ADDENDUM 1

DATE: June 21, 2019

Contract 19-C-00034; Saint Isabel Pumping Station Rehabilitation

No.	DATE	REVISIONS	DES:	JH	<p align="center">CITY of TAMPA WASTEWATER DEPARTMENT</p>	<p align="center">SAINT ISABEL PUMPING STATION REHABILITATION</p> <p align="center">PROPOSED PROFILE</p>	<p align="center">SHEET 7</p>
3			DRN:	MRL/JHJ			
2			CKD:				
1	6/18/19	Added Backflow Preventer Detail	DATE:

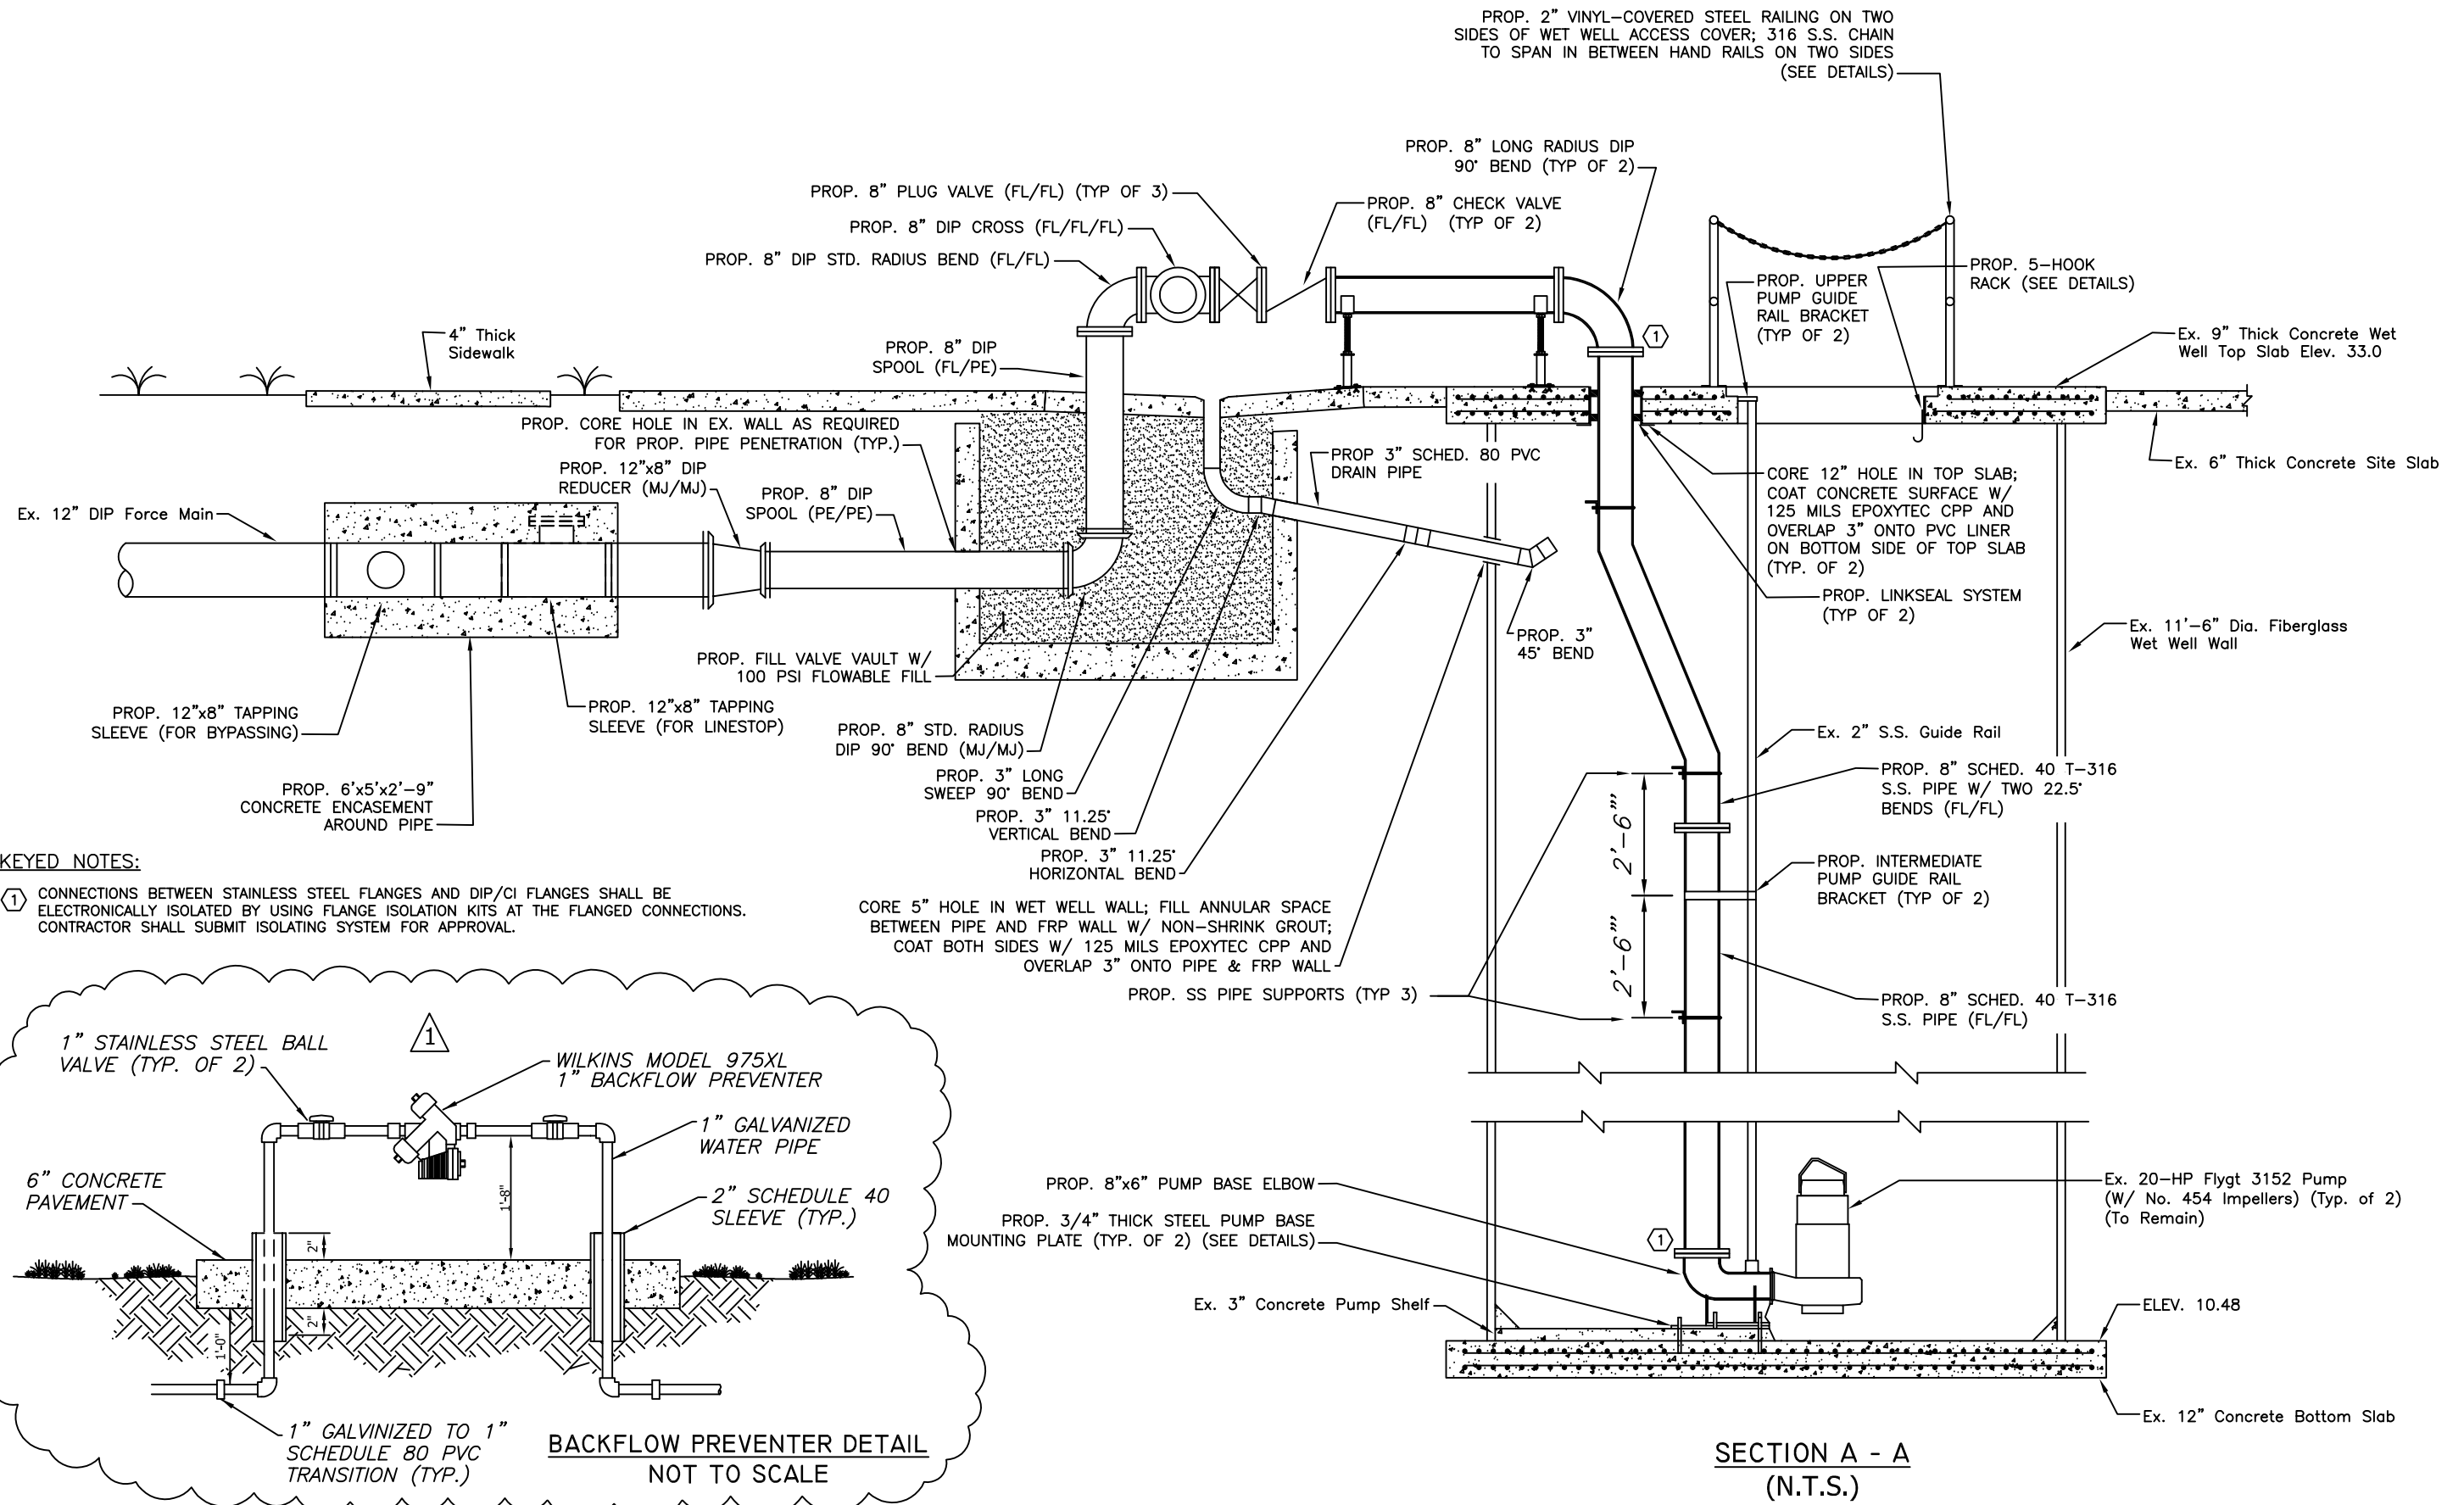
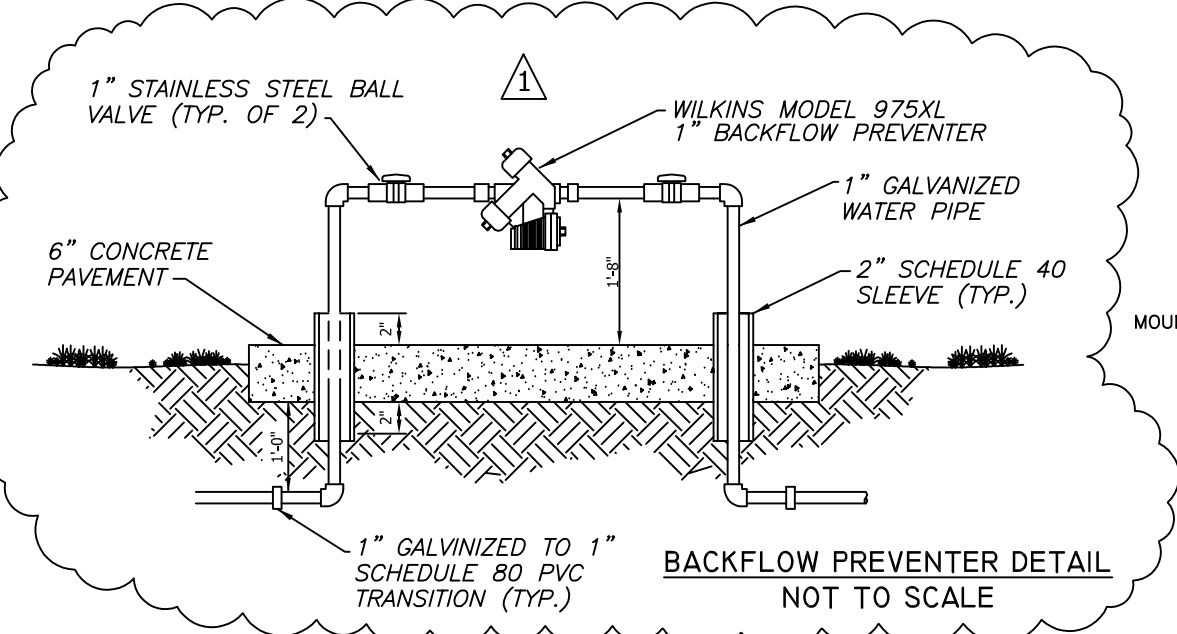
Item 2: Replace Plan Sheet 7 of the with the attached revised Sheet 7.
